Approval of Reserved Matters Consultation

Application Number: 243124

Site Address: Land At Bridge Farm, Bridge Farm Lane, Twyford, Berkshire

MEMORANDUM

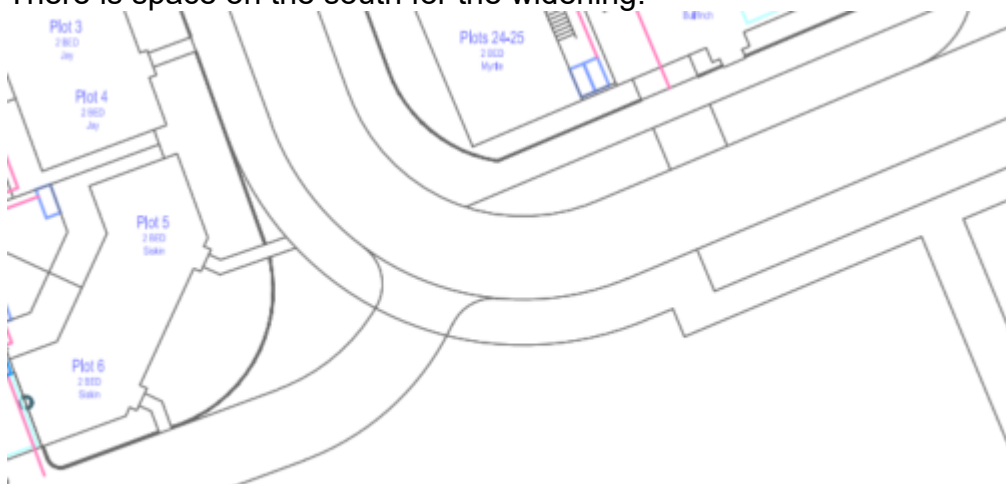
37. In the response to earlier comments, it was stated that the service margins were included in the highway layout plan. This is not the case. The service margins need to follow the standards, namely: -

38. Highways is concerned with the width of the bend on the main access route as shown below. The width of this bend would need to enable to refuse vehicles passing safely. Swept path analysis will determine this width. There is space on the south for the widening.
